## **ZONING CHANGE REVIEW SHEET**

CASE: C814-2018-0121 -- 218 South Lamar

TO: PUD

ADDRESS: 218 South Lamar Boulevard Southbound

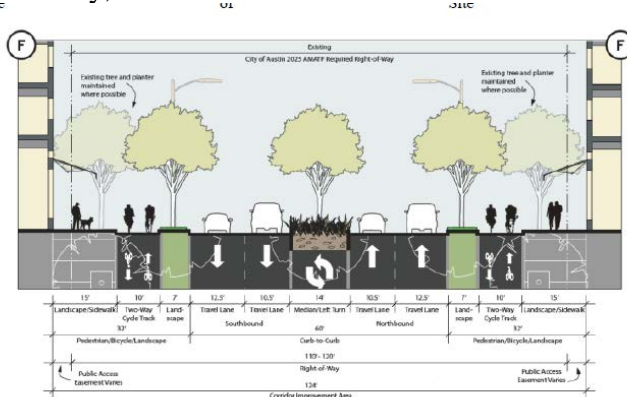
TR2. Include the below streetscape in the land use plan. Contact this reviewer for a more legible copy of it if necessary. This project is adjacent to a street that has been identified in Austin's Corridor Mobility Program (S Lamar). The sidewalk and bicycle facilities shall comply with the required cross-section at the time of the site plan application. The cross section that will be required is shown below. Find additional information about the Corridor Mobility Program here: <https://data.austintexas.gov/stories/s/Corridor-Mobility-Program/gukj-e8fh/>. Any proposed curb relocations on S Lamar requires coordination with the Corridor Planning Office and Bicycle Program. The cross section will include a 7' planting zone with street trees, a 10' two-way cycle track, and a 15' clear zone all behind curb. Additionally, a protected intersection will be required at Toomey, to be reviewed at the time of Site Plan.

4-Lane Divided, 60' Curb-to-Curb  
Back-of-Curb Condition F  
Barton Springs Road to Riverside Drive
